ADDENDUM NO. 01

**Bid #1472 Campus Entrance Improvements Phase 2
at
Santiago Canyon College**

Project ID #3742, DSA #04-122457

March 13, 2025

FOUNTAIN
ELECTRICAL
PLANS &
DETAILS

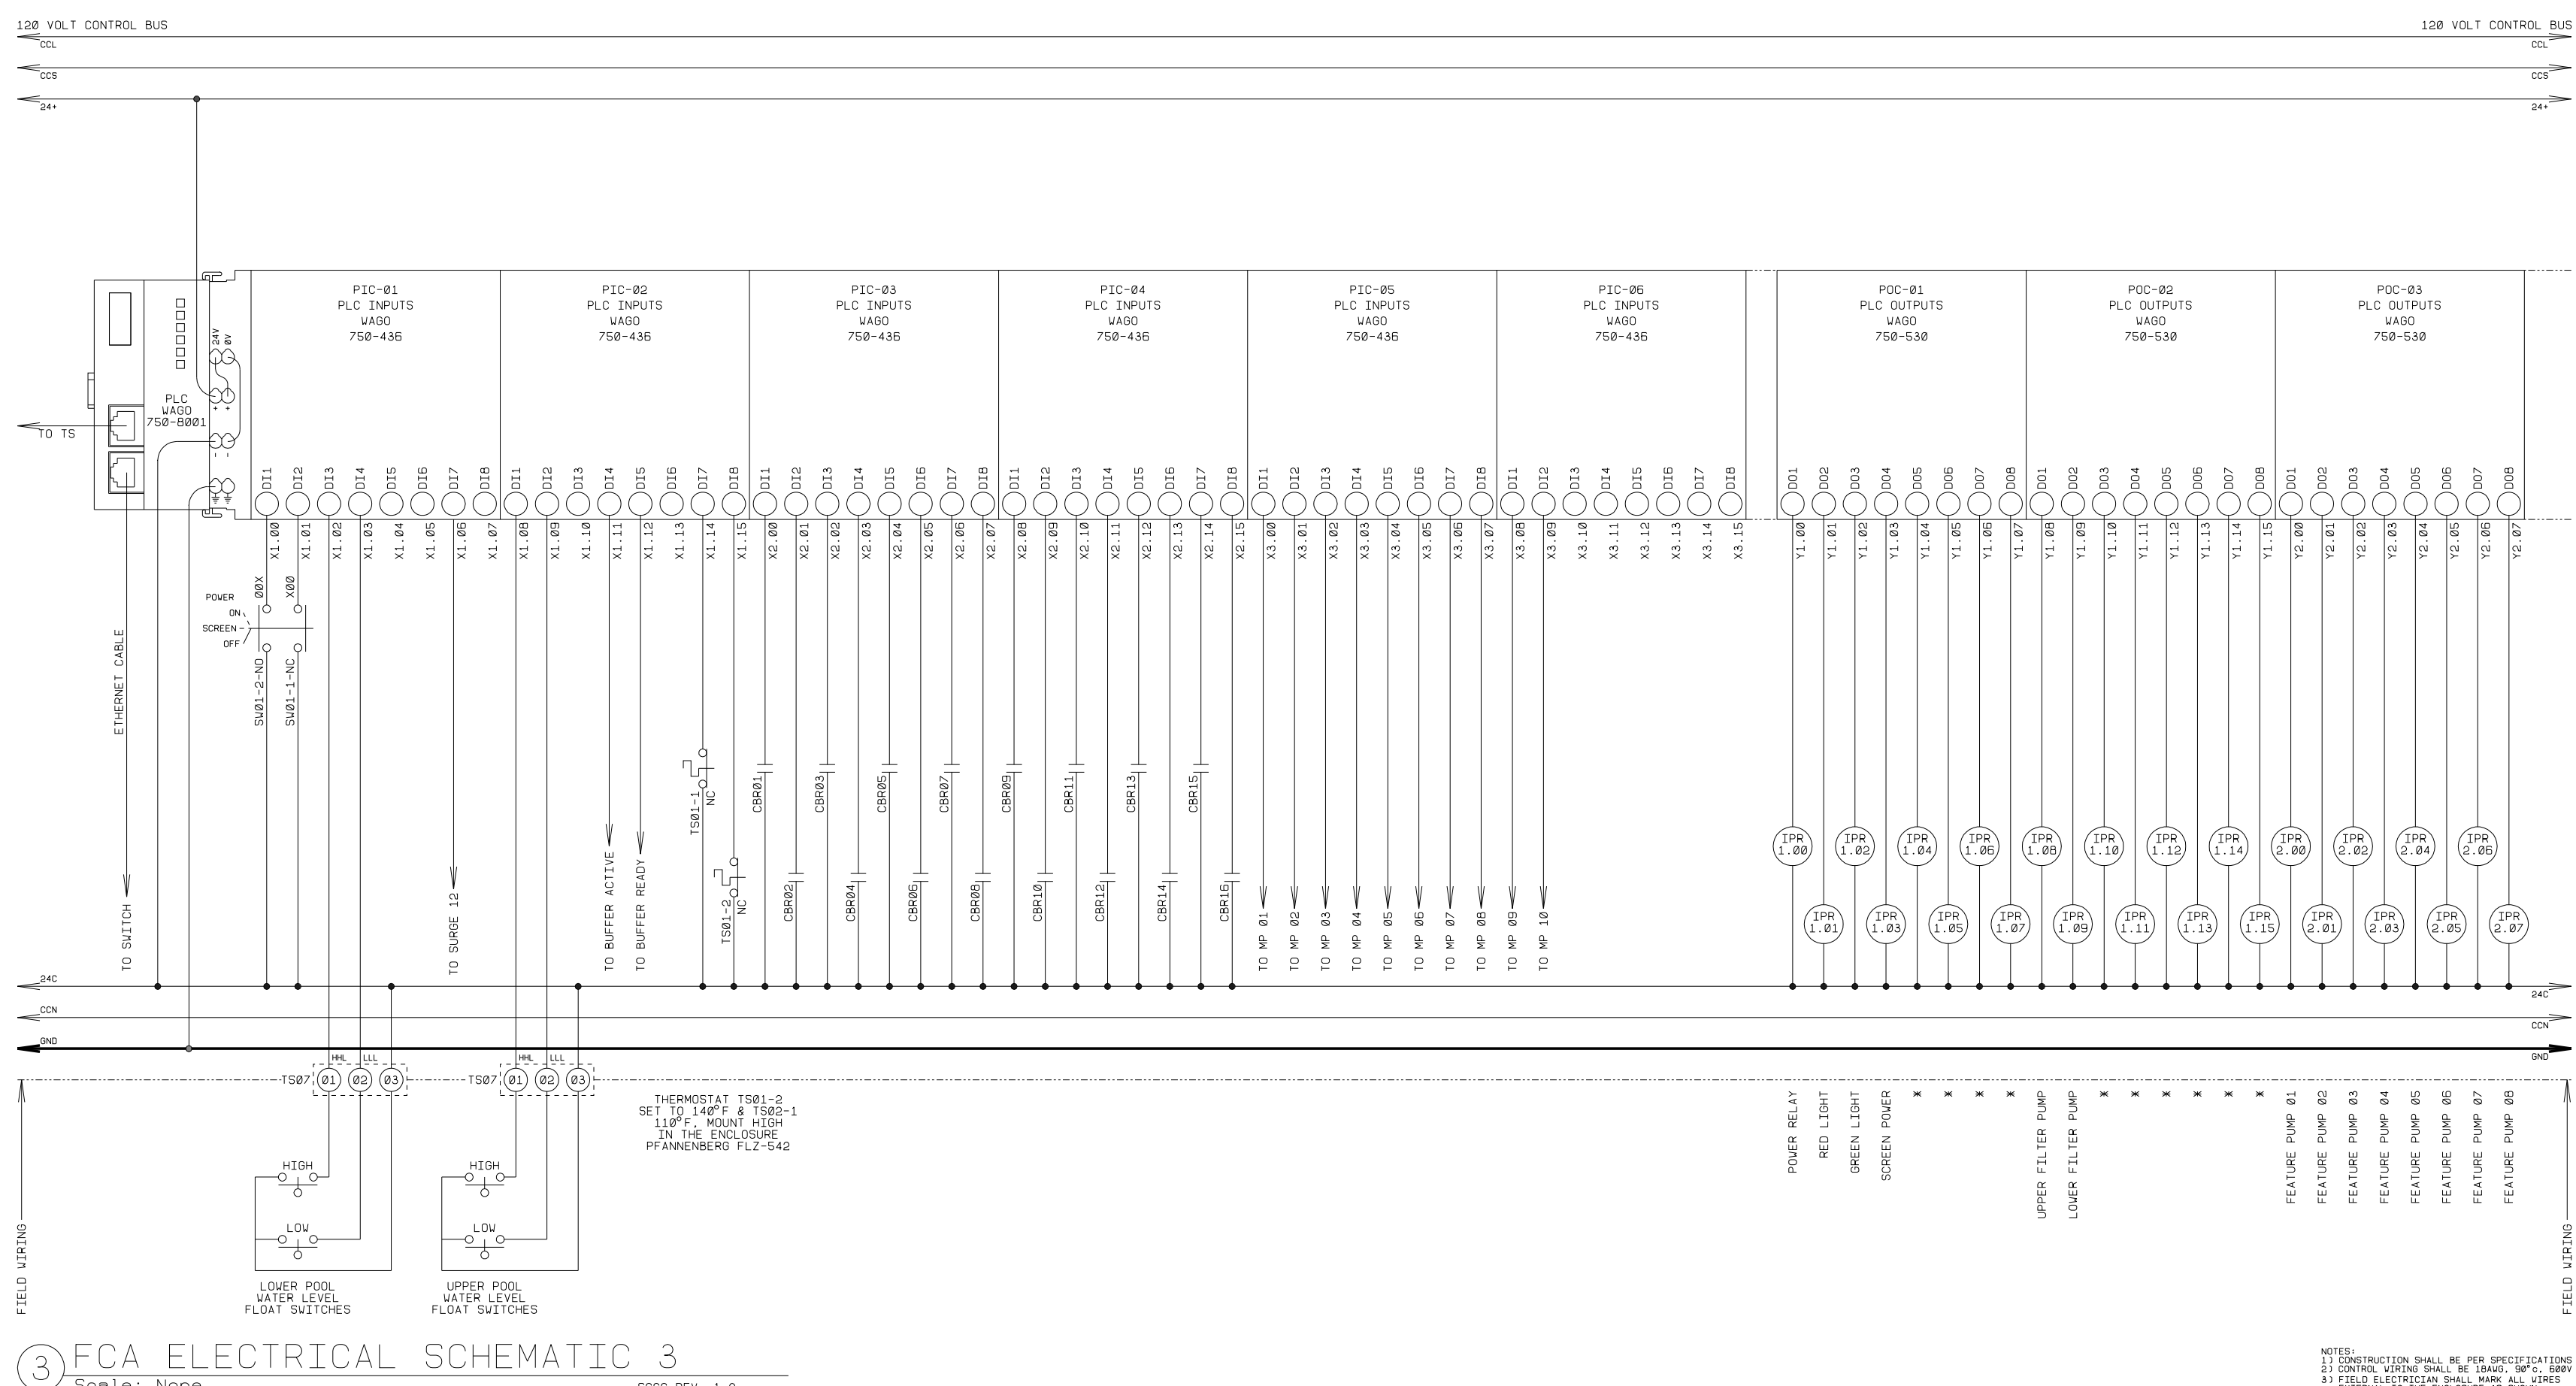
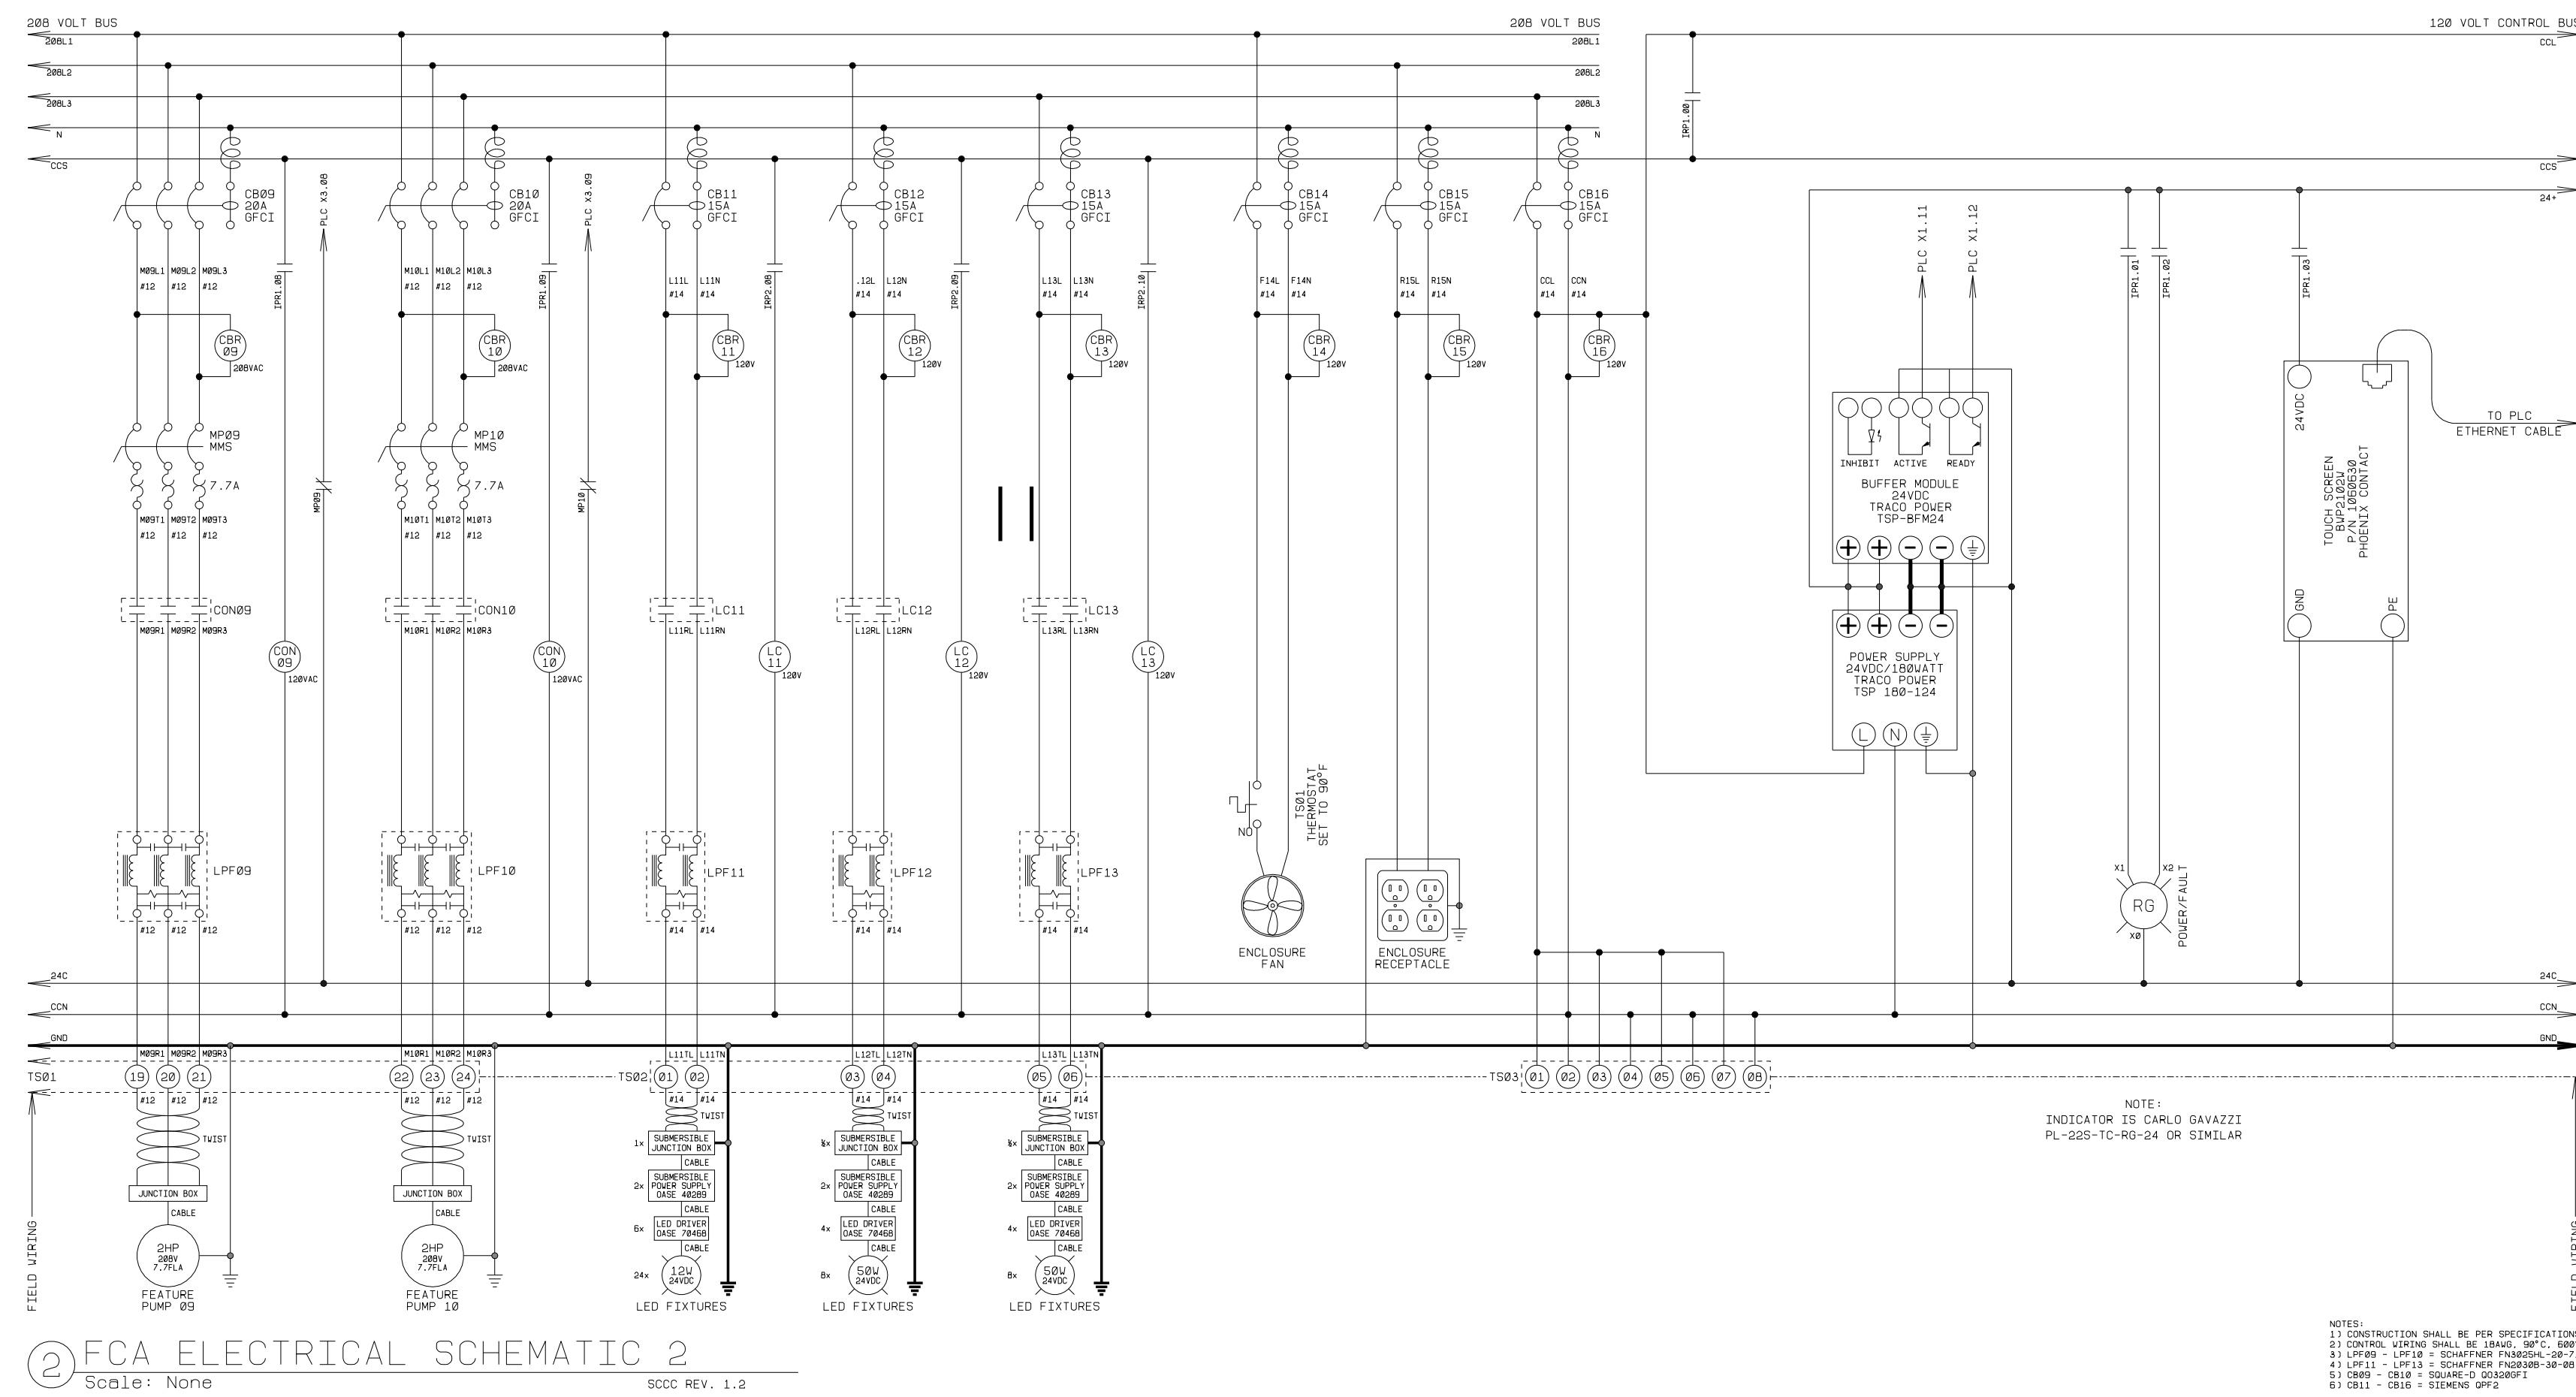
PROJECT NAME:	Campus Entrance Improvements Phase 2 Project at Santiago Canyon College		
PROJECT NUMBER:	3742	BID NUMBER:	1472
EMAIL TO: facilitiesbid@rsccd.edu			
DATE:	3/5/2025		
FROM:	Ryan Agnew - RJR Water Features	EMAIL:	ragnew@rjrwaterfeatures.com
SPEC SECTION:	Electrical/Controls	DRAWING NUMBER:	F-1.06 & F-1.07
REQUESTED CLARIFICATION:			
<p>The equipment load schedule on F-1.06 and the electrical schematic on F-1.07 do not match.</p> <p>F-1.06 matches the equipment shown throughout the plans, while F-1.07 has multiple additional items not shown on the plans.</p> <p>Please advise if a revised electrical schematic will be provided.</p>			
RESPONSE TO CLARIFICATION:			
<p>Please use Addendum 2, revised electrical sheets F-1.05, F-1.06, and F-1.07.</p> <p>SVA, 3/13/2025</p>

PROJECT NAME:	Campus Entrance Improvements Phase 2 Project at Santiago Canyon College		
PROJECT NUMBER:	3742	BID NUMBER:	1472
EMAIL TO: facilitiesbid@rsccd.edu			
DATE:	3/5/2025		
FROM:	Ryan Agnew - RJR Water Features	EMAIL:	ragnew@rjrwaterfeatures.com
SPEC SECTION:	Electrical/Controls	DRAWING NUMBER:	F-1.06
REQUESTED CLARIFICATION:			
<p>Clarification is needed on the fountain lighting controls. Is the fountain control panel providing power AND control for the lights located in the fountain basins, or are the lights being controlled by an external controller?</p>			
RESPONSE TO CLARIFICATION:			
<div style="border: 2px solid green; padding: 10px; margin-top: 10px;"><p>The fountain control will provide lighting power. Please use Addendum 2, revised electrical sheets F-1.05, F-1.06, and F-1.07.</p><p>SVA, 3/13/2025</p></div>

- A. **F-1.05 – Detail 1:** The wiring and conduit for the light power supplies have been relocated to the West J-box for ease of installation.
- B. **F-1.05 – Detail 2:** Filter pumps have been included in the detail.
- C. **F-1.06 – Detail 1:** The electrical plan has been updated to reflect new light fixtures and power supply layout. The originally specified lights are no longer available.

- D. **F-1.07 – Details 1 thru 4:** The electrical schematics have been updated to include the three new lighting circuits.
- E. **F-1.07 – Detail 2:** Float switch detail has been included.
